**PARAPETS / RAILS / MEDIANS / SIDEWALKS
VDOT STANDARD PARAPETS AND RAILS
STANDARD TYPES**

COMMONWEALTH OF VIRGINIA DEPARTMENT OF TRANSPORTATION					
STRUCTURE AND BRIDGE DIVISION					
CAST-IN-PLACE CONCRETE MEDIAN BARRIER (F-SHAPE)					
No.	Description	Date	Designed: S&B, DIV	Date	Plan No.
			Drawn: ...S&B, DIV		Sheet No.
			Checked: S&B, DIV		
Revisions			BMB-5A

COMMONWEALTH OF VIRGINIA DEPARTMENT OF TRANSPORTATION		
			STRUCTURE AND BRIDGE DIVISION		
			42" CAST-IN-PLACE CONCRETE PARAPET (F-SHAPE)		
No.	Description	Date	Designed: S&B, DIV	Date	Plan No.
			Drawn: S&B, DIV		Sheet No.
			Checked: S&B, DIV		
Revisions			BPB-4A

COMMONWEALTH OF VIRGINIA DEPARTMENT OF TRANSPORTATION					
STRUCTURE AND BRIDGE DIVISION					
PIER PROTECTION SYSTEM					
No.	Description	Date	Designed: S&B, DIV	Date	Plan No.
			Drawn: S&B, DIV		
			Checked: S&B, DIV		
Revisions			BPPS-2

SECTION A-A

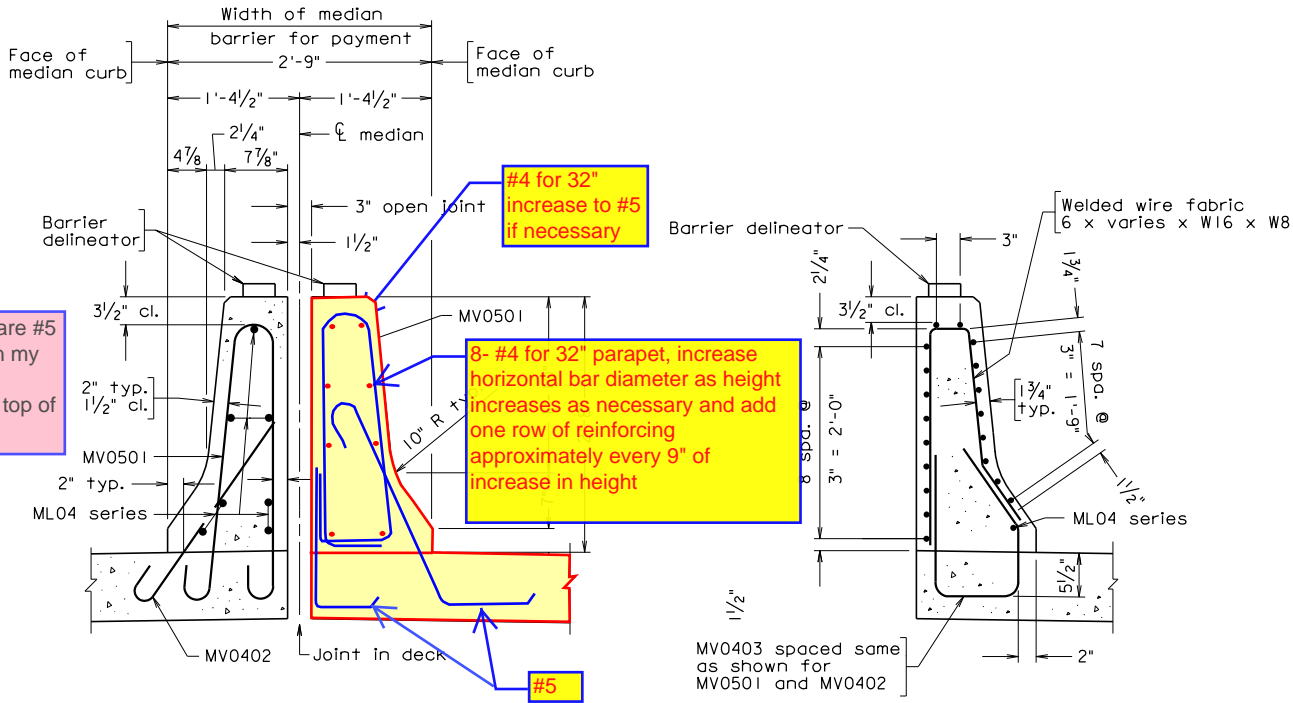
existing barrier rebar on Left
proposed rebar on right

Front row is #4, 2nd and 3rd rows are #5 (raises strain compatibility issues in my mind)
7-#4 bars including only one at the top of the railing.

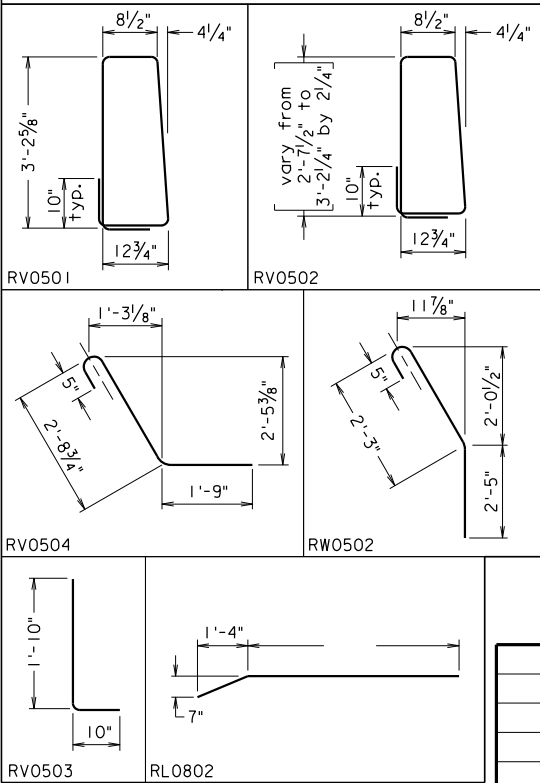
TL-5 42" barrier

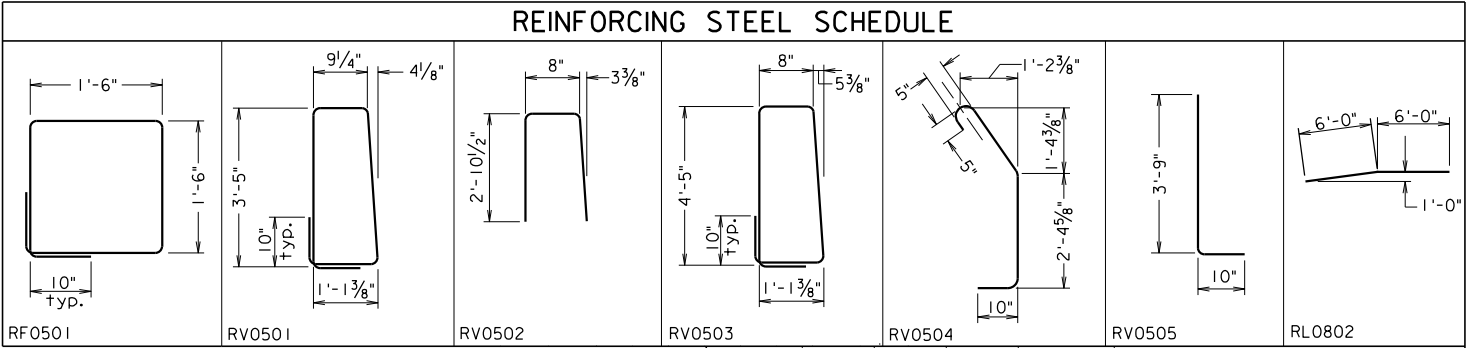
54" TL-5 reinforcing pattern to be modified for the deck if required.
